Swt 6-12-00
REQUEST FOR SERVICE

County of Sonoma
 Permit And Resource Management Department
 Well & Septic Section
 2550 Ventura Avenue, Santa Rosa, CA 95403 (707) 565-1900

Location Address 31405 SEAVIEW RD.	City, Zip CAZADERO CA. 95421
Owner/Facility Name KEVIN LOREN & PETER COOPER THWATHE	Assessor's Parcel # 109-530-006
Address of Owner 1415 3RD ST.	City, State, Zip SAN RAFAEL CA 94901
Person Requesting Service JOE MERCECA (BOHAN & CANELIS)	Phone 632-5708
Address of Person Requesting Service PO BOX 186	City, State, Zip CAZADERO CA 95421
Description <b style="text-align: center;">SITE REVIEW FOR PERC TEST	
By _____

Pre-Perc Field Notes

Site Map:

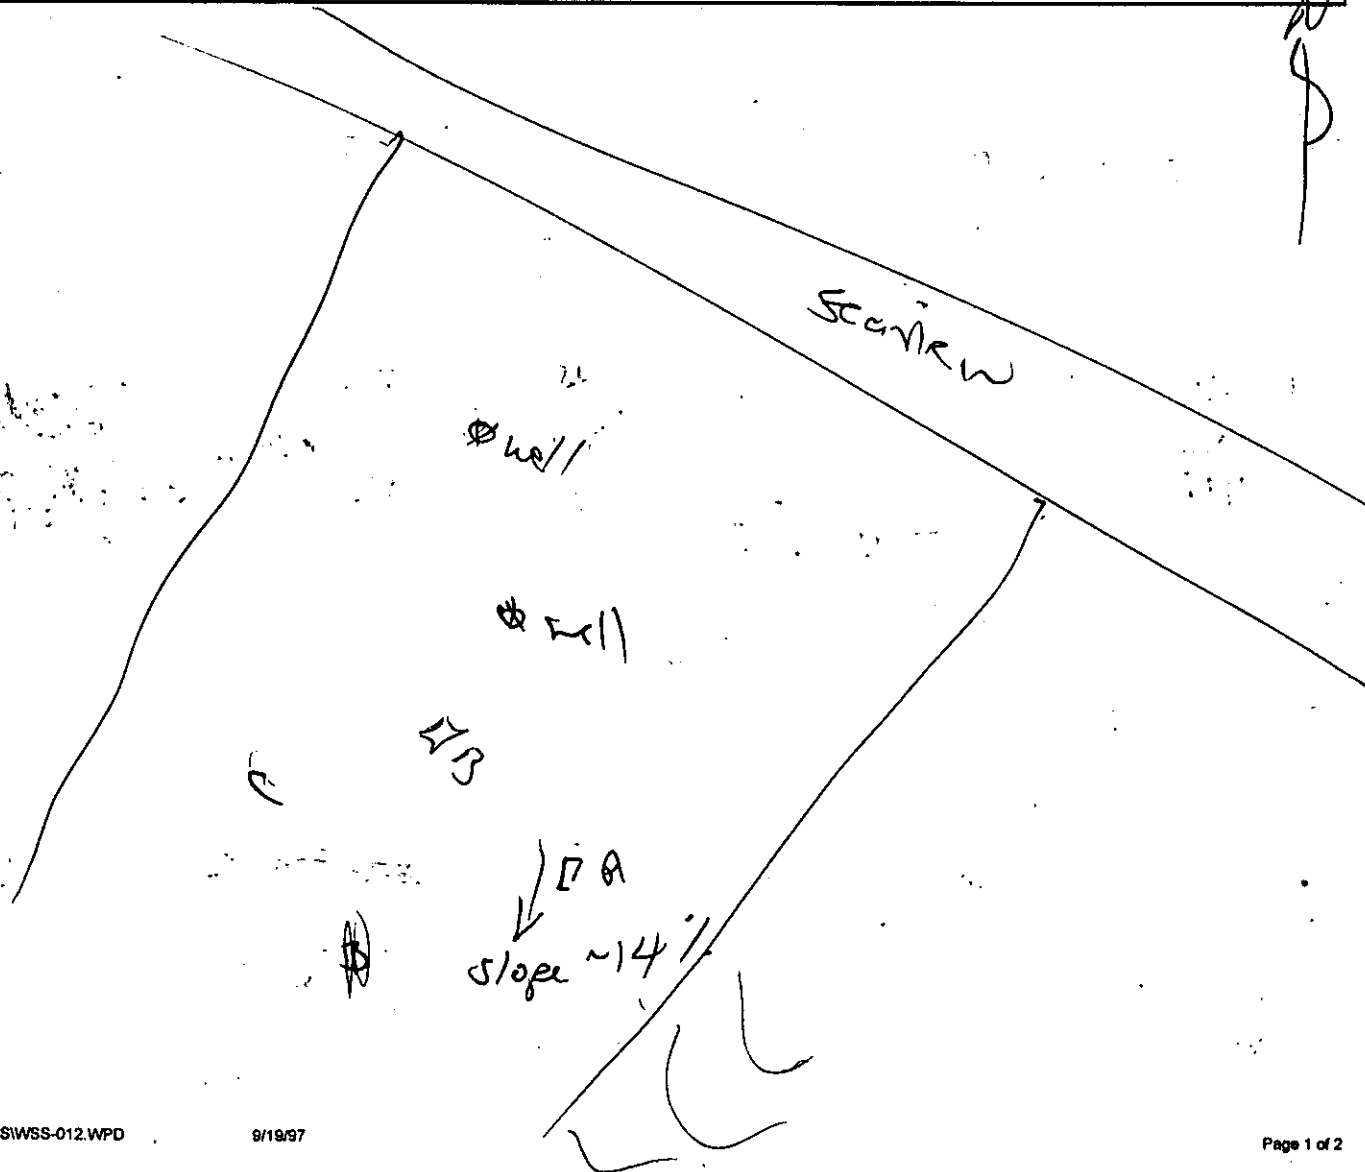
Soil profiles revealed suitable conditions to test for:

fl area	A & C	perc	hydro	24"
std area	B	"	"	36, 72"

100' setback to wells.
